Comments on #SDP-26-0002 - Planning & Zoning: Site Development Plan

Application Number: #SDP-26-0002
Application Type: Site Development Plan
Date: September 8, 2026
Address: 5109 Mitchell Mill, Rolesville, NC 27571

**MITCHELL MILL MARKET
TOWN OF ROLESVILLE WAKE COUNTY NORTH CAROLINA
SITE DEVELOPMENT PLANS
EXISTING CONDITIONS &
DEMOLITION PLAN**

VIEWPORT 17
HORIZONTAL: 1" = 5'

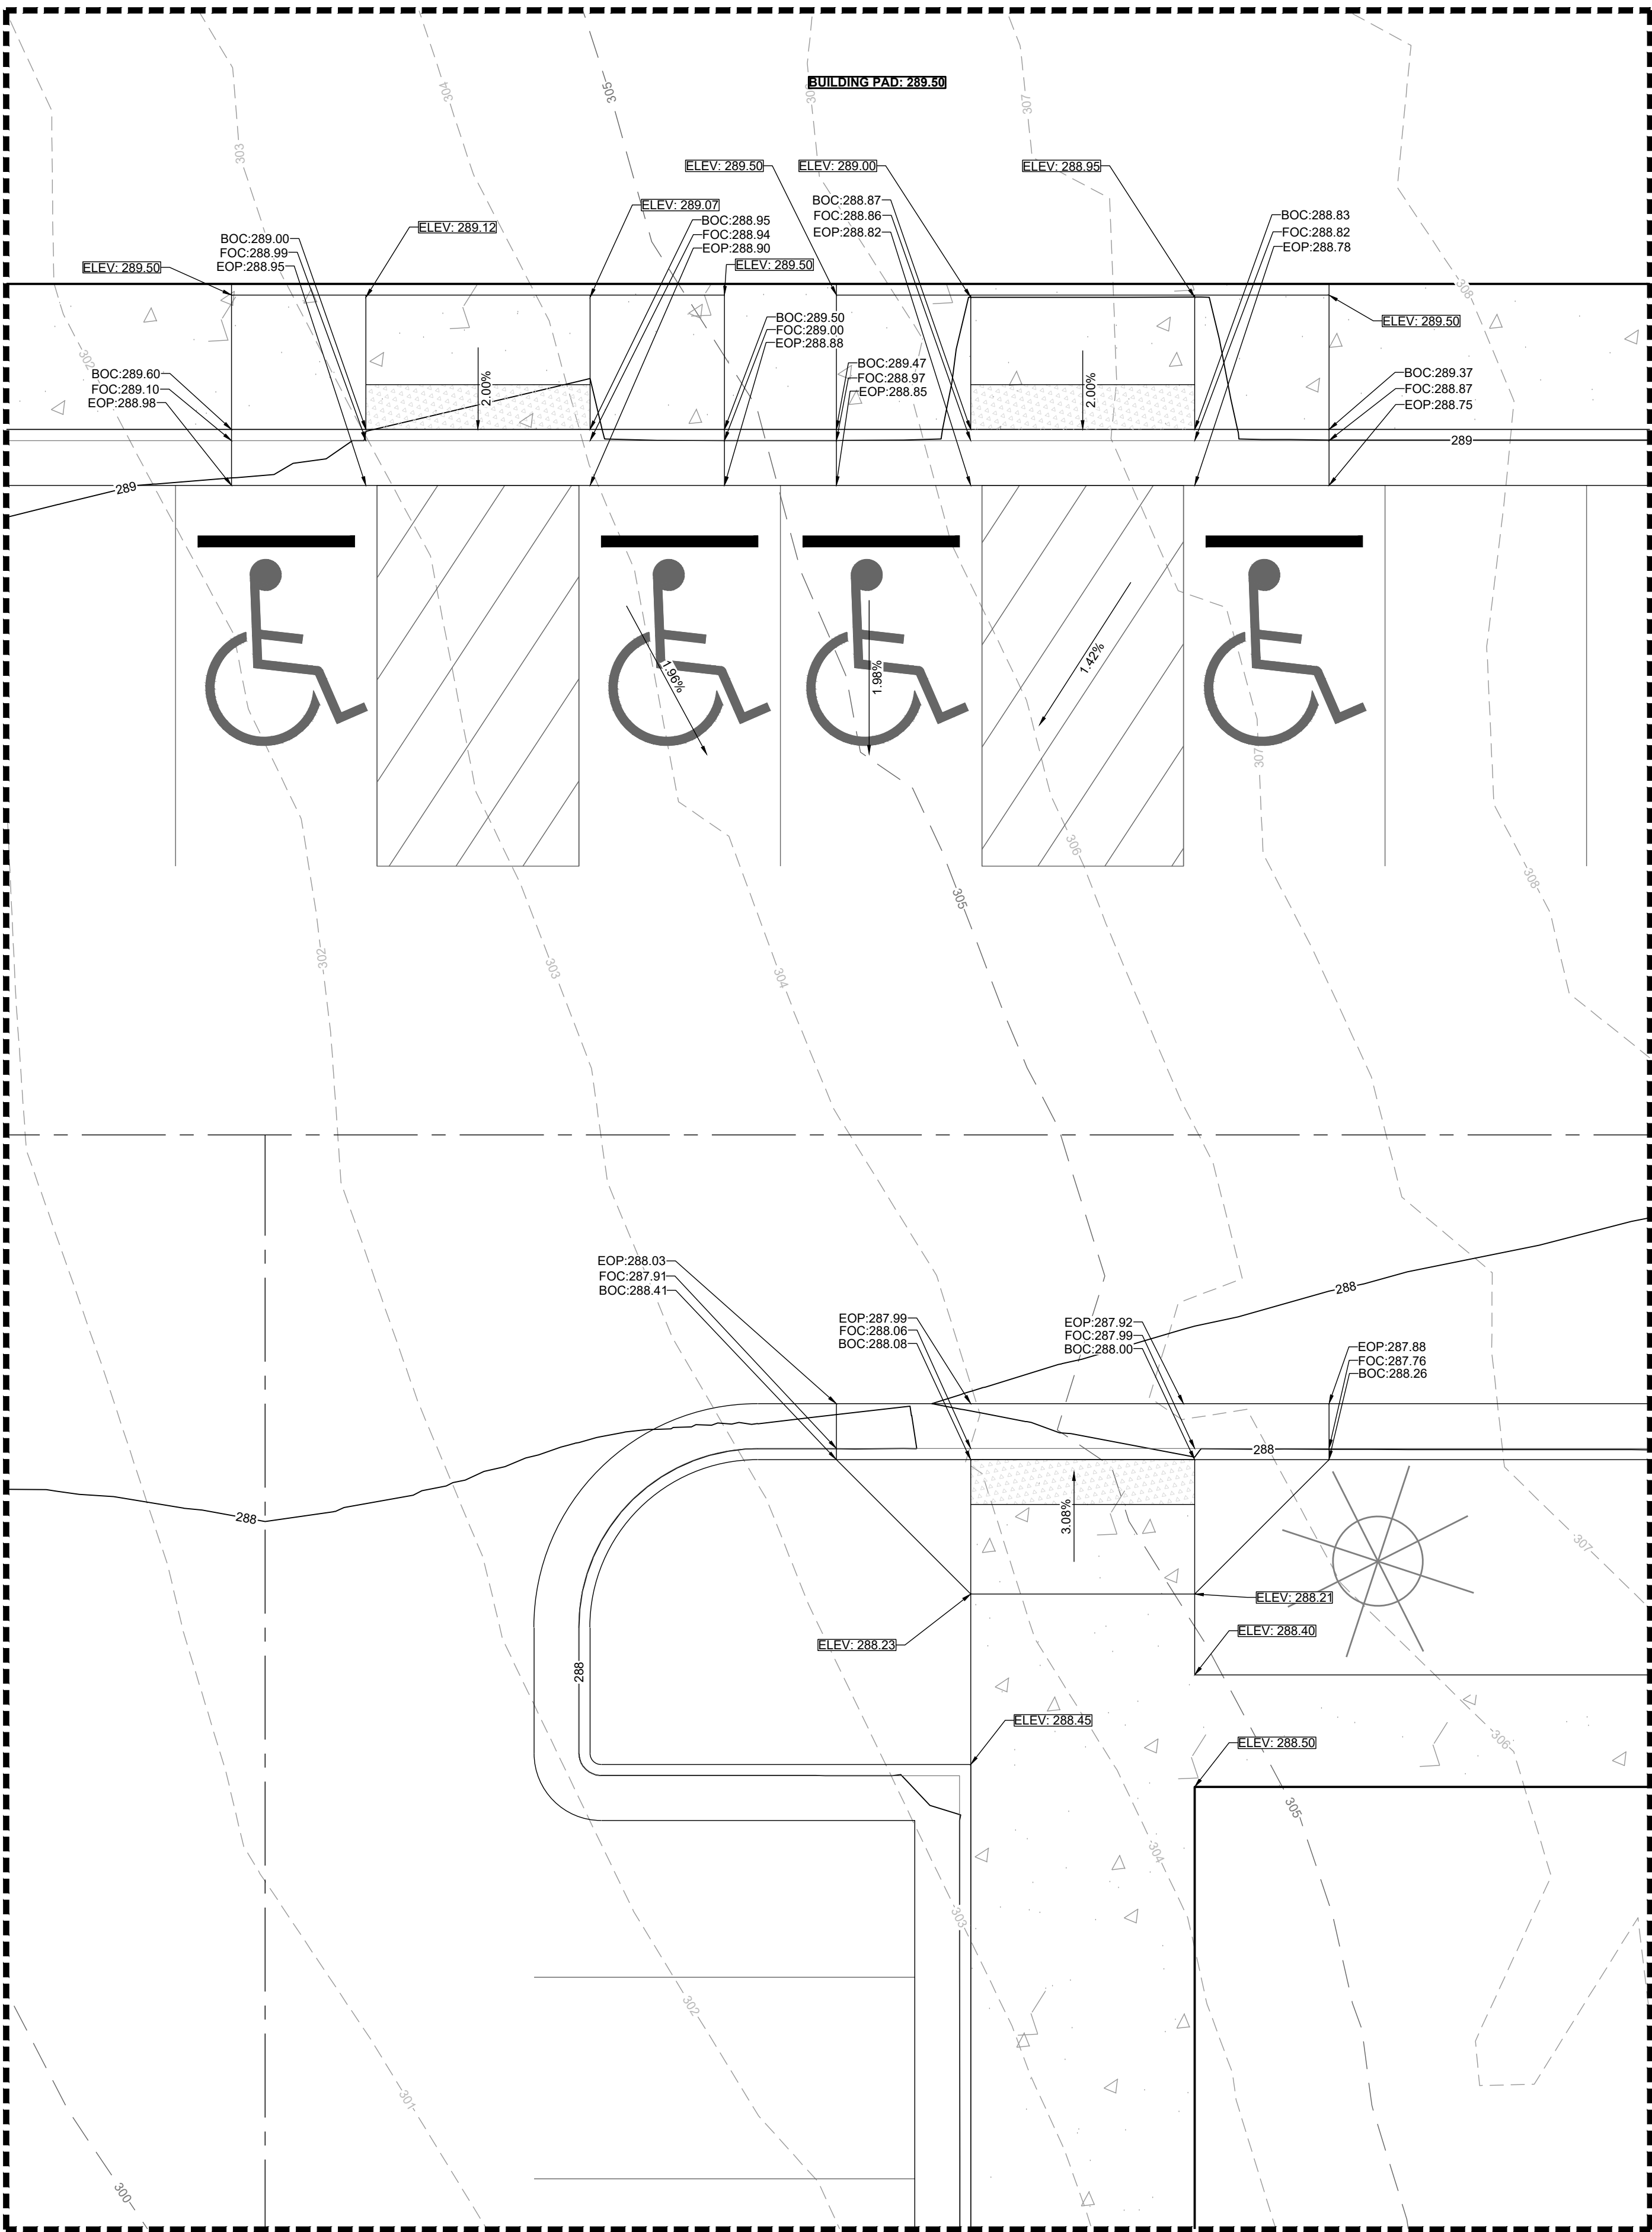
All ramps are ensured to provide a 5' x 5' landing of 2% or less, see Sheets C6.3 - C6.8

DRAWING SHEET
D-4.5

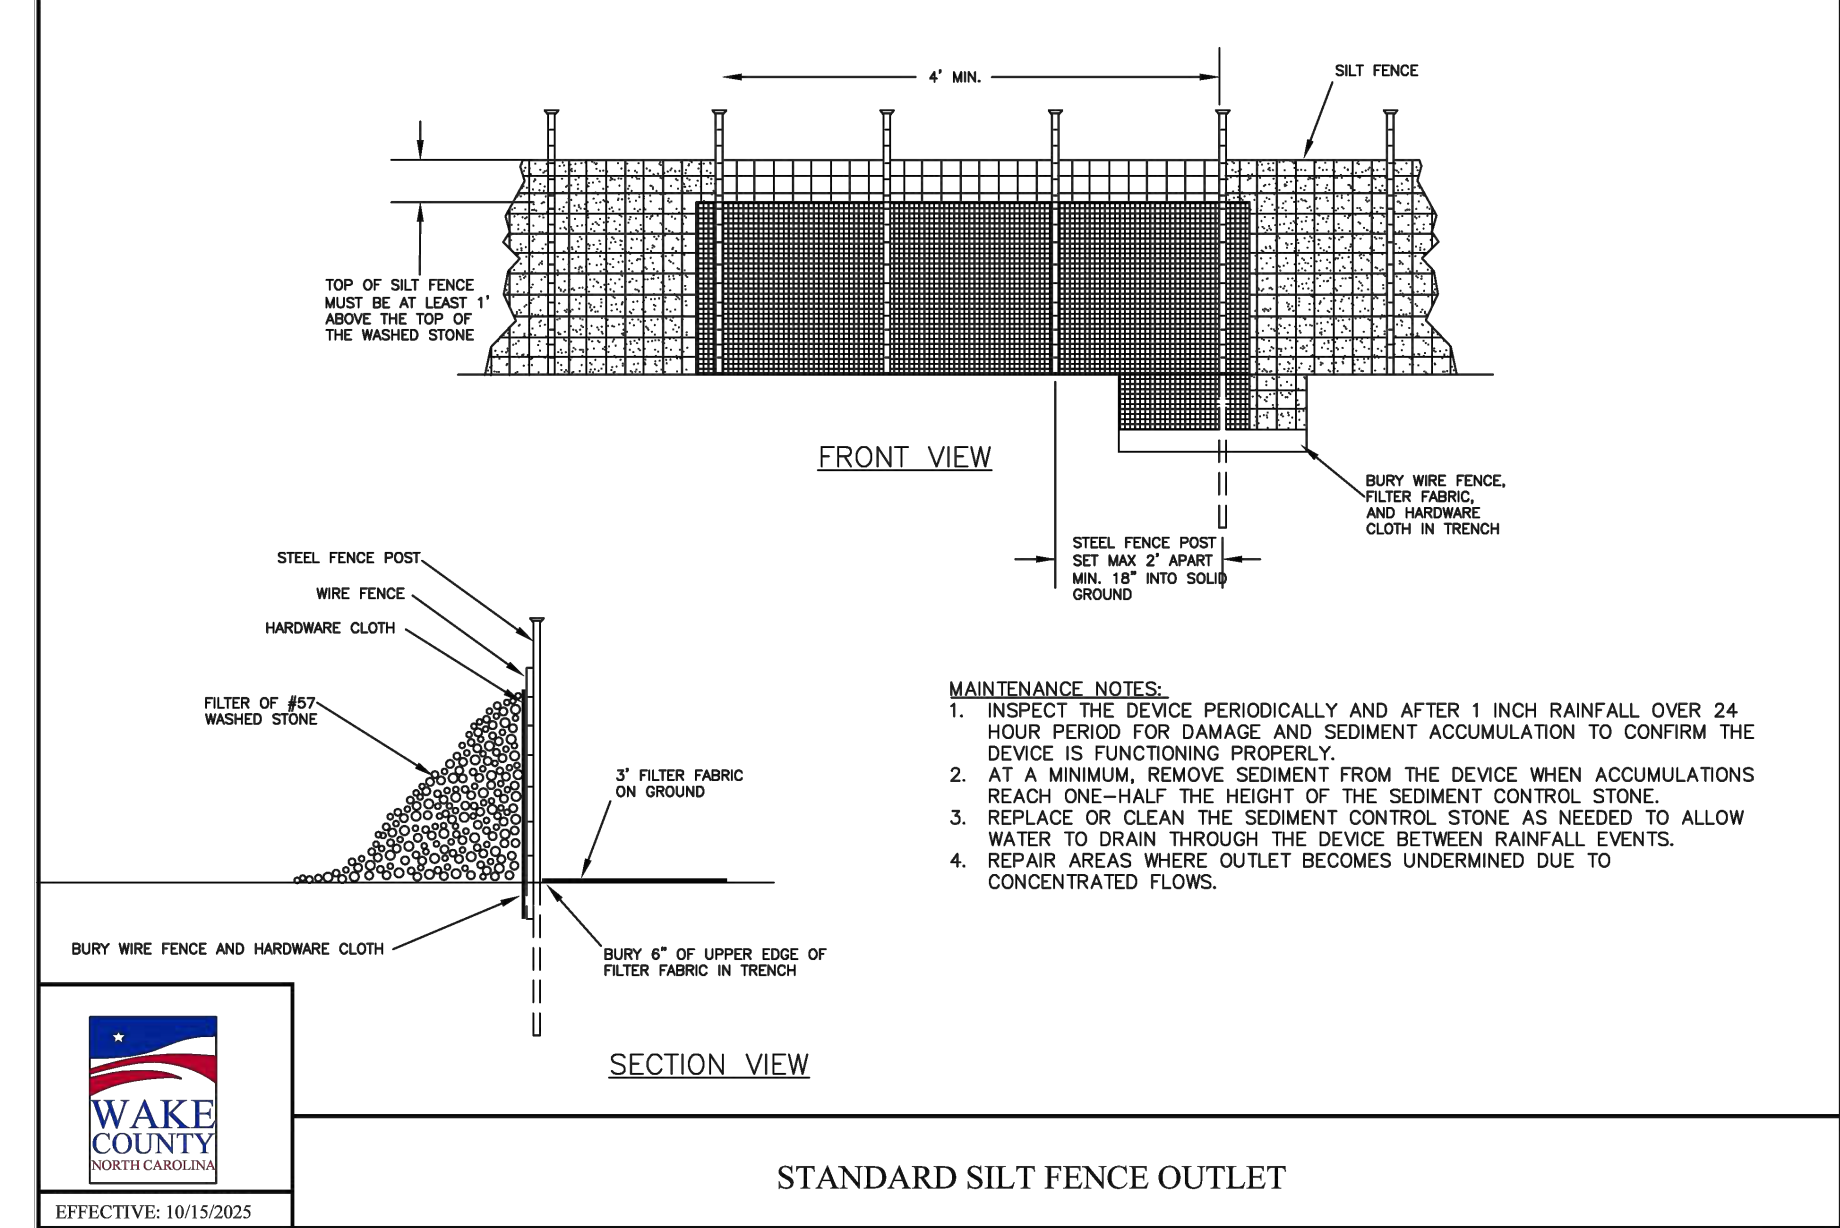
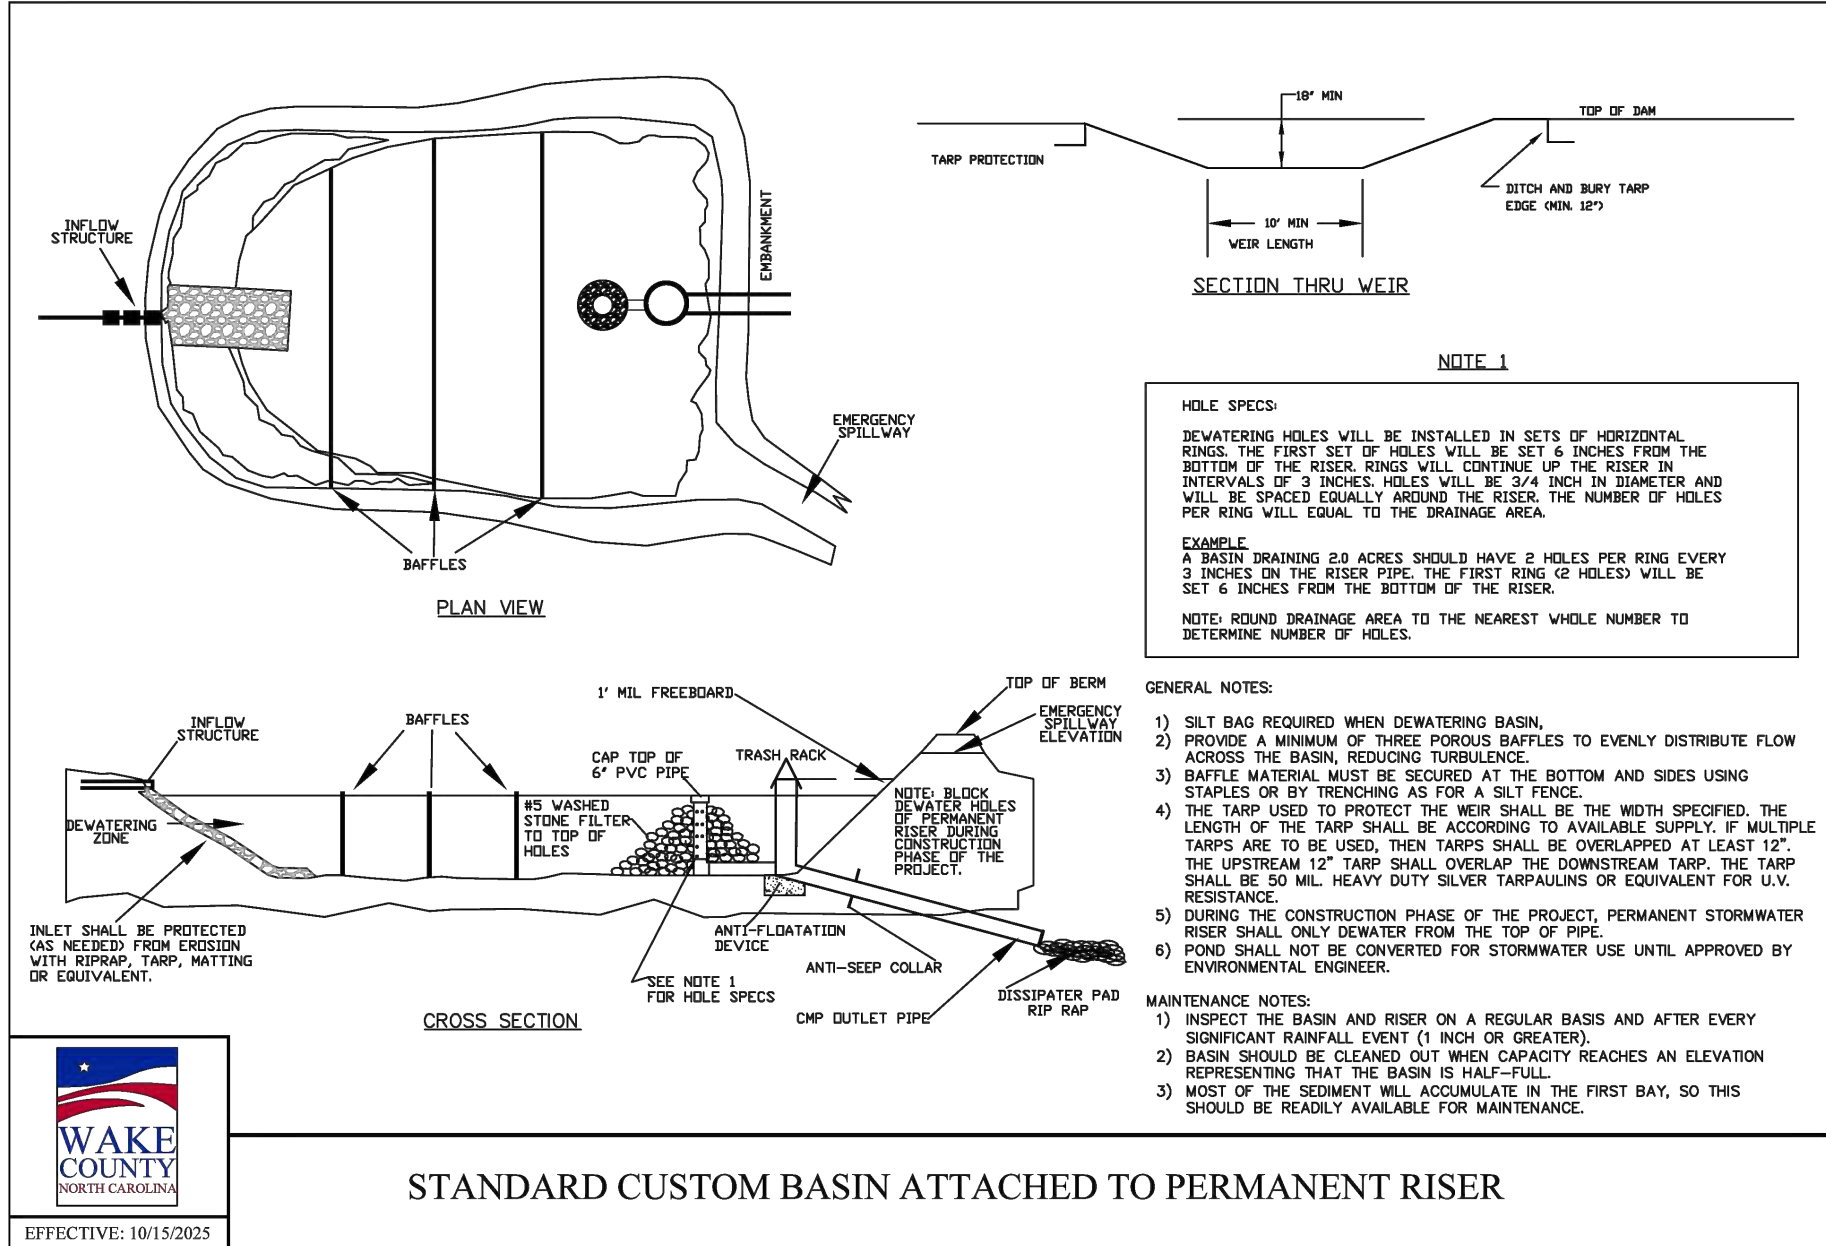
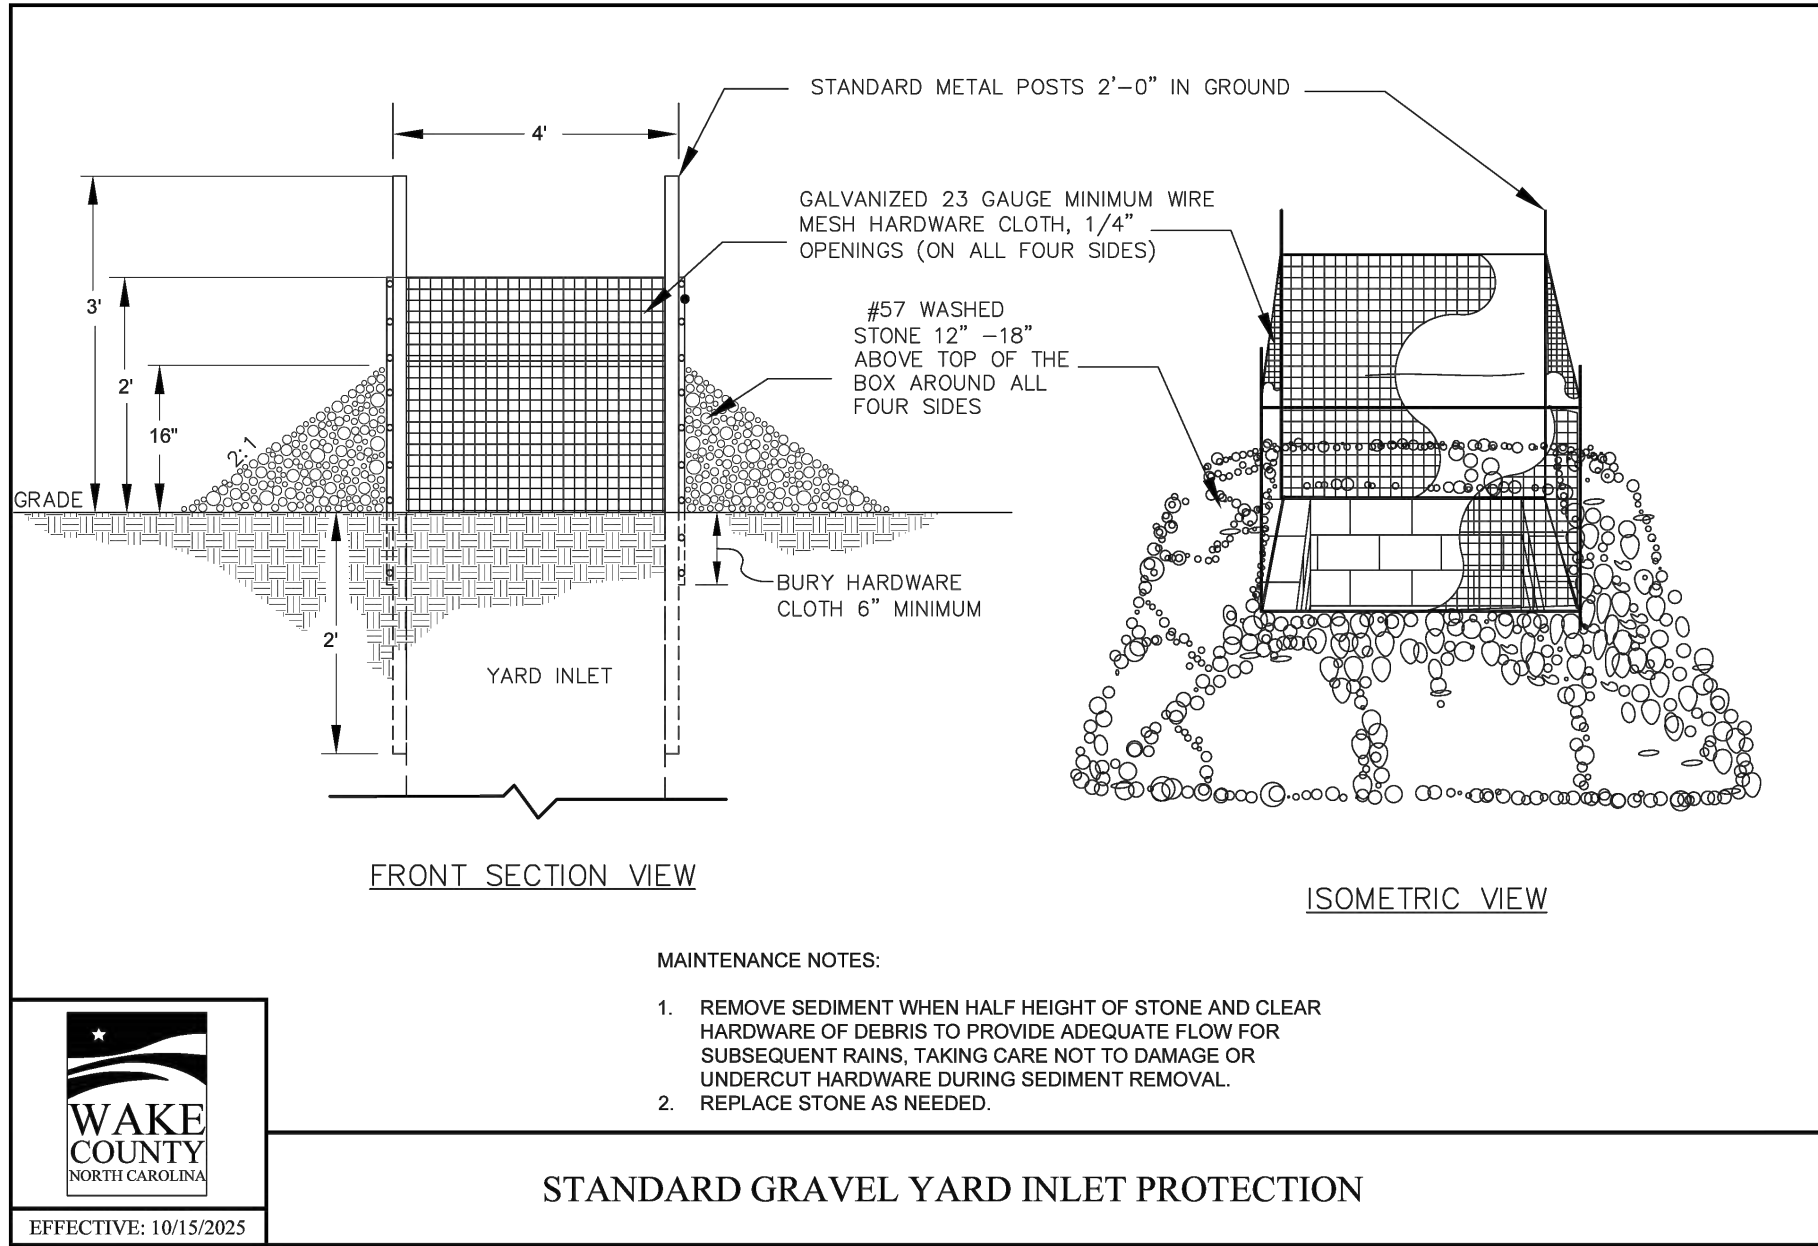
SREG Response: All curb cuts have been reviewed, and the grading has been updated to ensure positive drainage. A curb cut detail has been included on sheet D-4.5
